TO: Freightliner Principals, General Managers, Sales Managers, Service Managers, Parts Managers	FROM: Anthony Washington, Department Manager, Regulations and Certifications
<b>Re: Recall Campaign Launch Notification Model 907 (Sprinter) Model Years 2020 Inspect Swivel Seat Wiring Harness Routing</b>	DATE: August, 2021

Campaign No. 2021070031, August, 2021

SUBJECT: **Model 907 Sprinter, Model Year 2019-2021  
Inspect Swivel Seat Wiring Harness Routing**

D91.10-A026-76

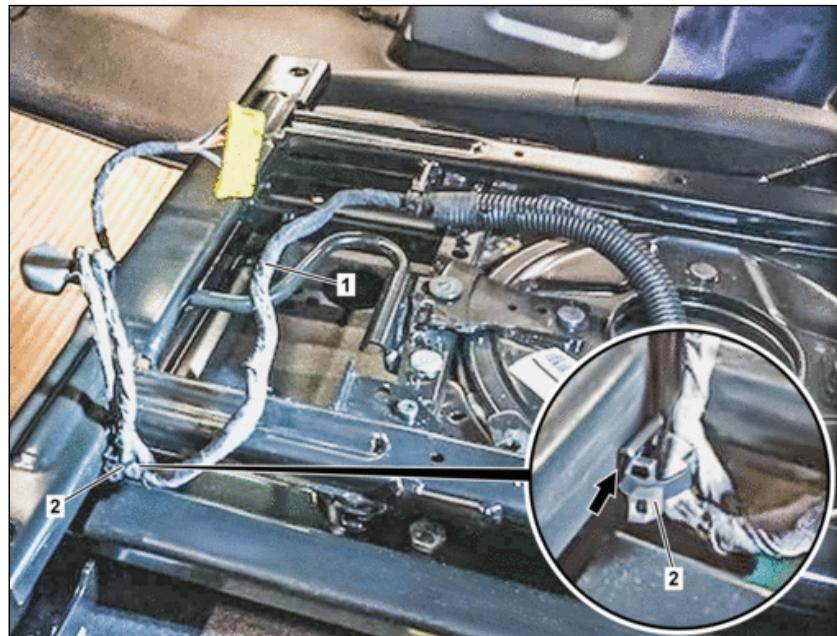
**Shown on driver's seat with code SF1 (Electrically adjustable driver's seat) and code SR8 (Driver's seat rotating frame)**

1 Wiring harness

2 Cable tie with retaining clip

3	<p>Subsequently adapt line installation and attachment of wiring harness (1) to respective rotating seat.</p>	<p><b>i</b></p> <p>To do so, check if the wiring harness (1) is correctly fastened to the respective rotating seat frame using a cable tie with retaining clip (2).</p> <p>The wiring harness (1) must be positioned in the corner (arrow) of the rotating seat frame, as shown in the picture, and fixed in place using a cable tie with retaining clip (2).</p> <p>If cable tie with retaining clip (2) is not present,</p> <p style="text-align: center;">↓</p> <p>subsequently fasten wiring harness (1) to rotating seat frame using retaining clip (2). To do so, position wiring harness (1) along cable tie with retaining clip (2) in corner (arrow) of rotating seat frame. See figure.</p> <p>If cable tie with retaining clip (2) is present,</p> <p style="text-align: center;">↓</p> <p>position wiring harness (1) correctly on rotating seat frame. To do so, position wiring harness (1) along cable tie with retaining clip (2) in corner (arrow) of rotating seat frame. See figure.</p>

D91.10-A027-82

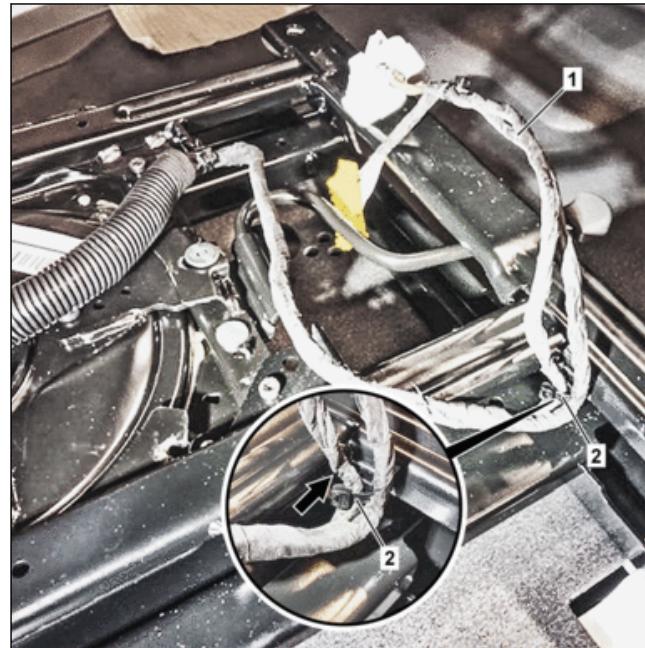
**Shown on driver's seat with code SF2 (Electrically adjustable front passenger seat) and code SR9 (Front passenger seat rotating frame)**

- 1 Wiring harness
- 2 Cable tie with retaining clip
